UNITED STATES PATENT AND TRADEMARK OFFICE

Office Action Summary

09/848,819

DETAILED ACTION

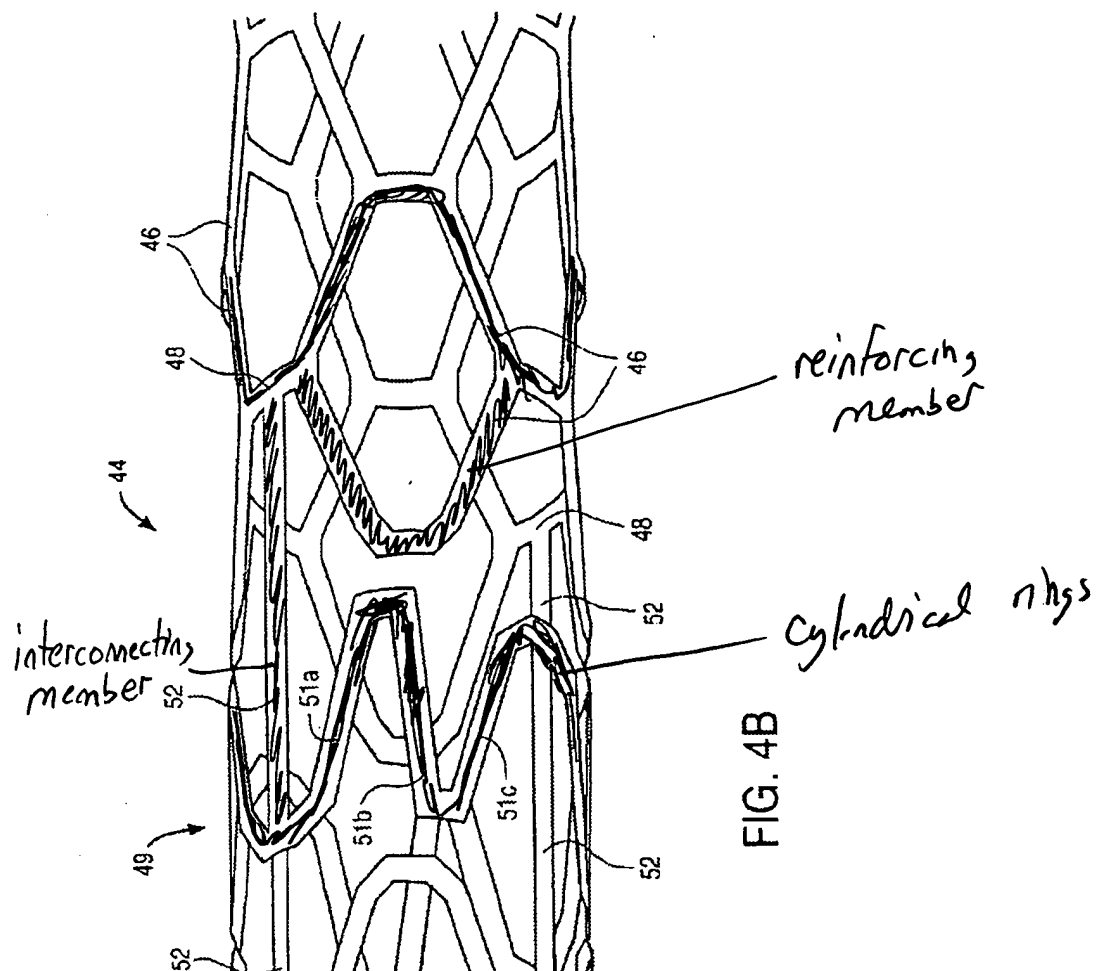
2. Claims 24,25 are rejected under 35 U.S.C. 102(e) as being anticipated by Klein US PN 5,593,442.

See figure 4B below specifically showing location of the cylindrical rings, reinforcing members, and interconnecting members. Also see abstract and lines 61-64 of col. 4 incorporating US PN 5,102,417, which discloses in lines 3-34 of col. 11 coatings for stents.

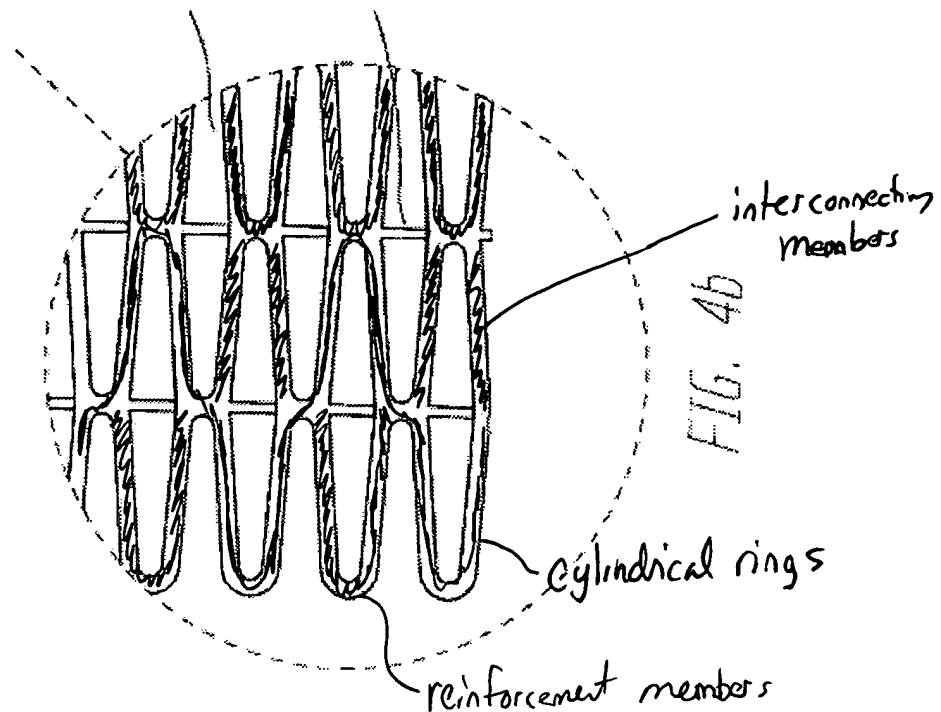
3. Claim 24 is rejected under 35 U.S.C. 102(e) as being anticipated by Killion US PN 5,868,781.

See figure 4b below specifically showing location of the cylindrical rings, reinforcing members, and interconnecting members in figure 4B. Also see lines 16-27 of column 5.

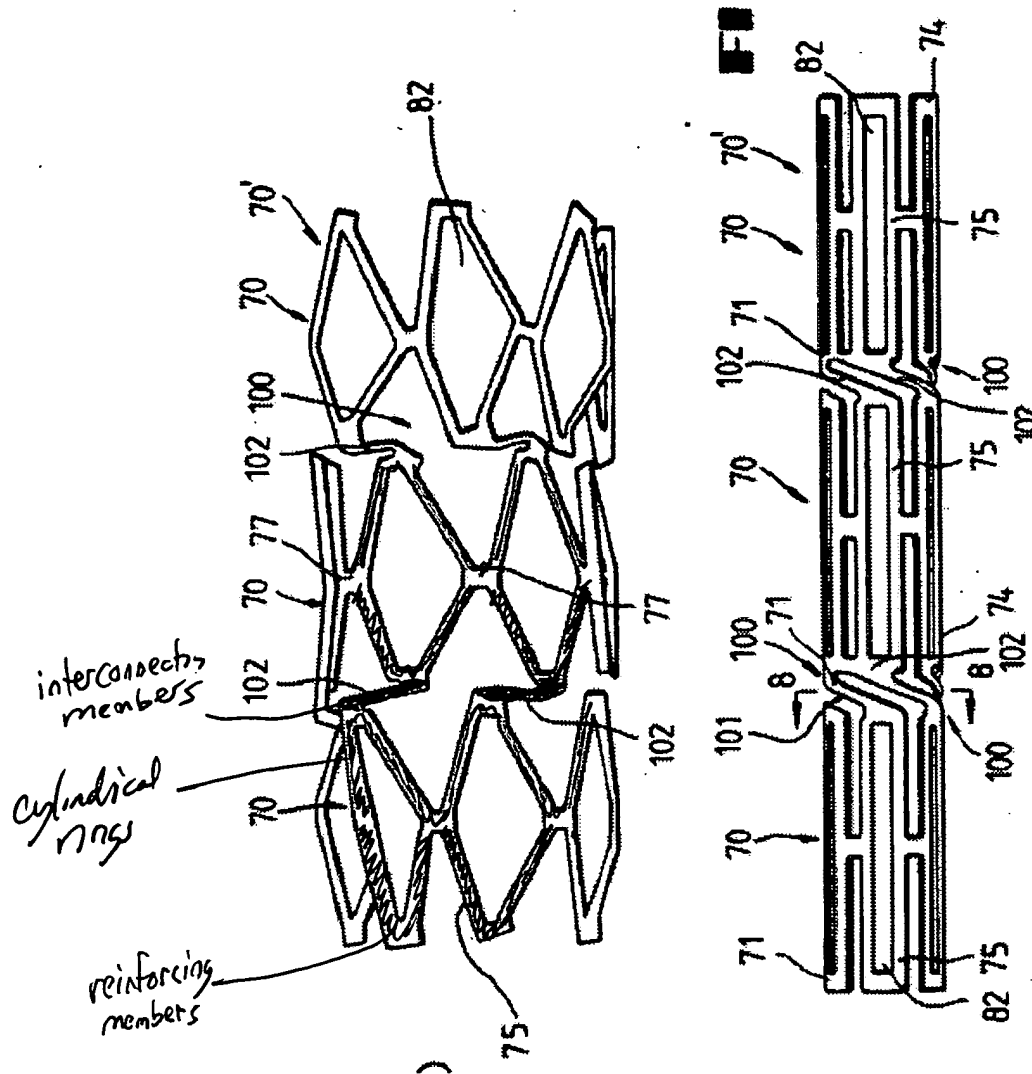
4. Claims 24-25 are rejected under 35 U.S.C. 102(b) as being anticipated by Palmaz US PN 5,102,417.

See figures 7 and 10 below specifically showing locations of the cylindrical rings, interconnecting members, and reinforcing members. Lines 3-34 of col. 11 disclose biocompatible coatings for use with stents.
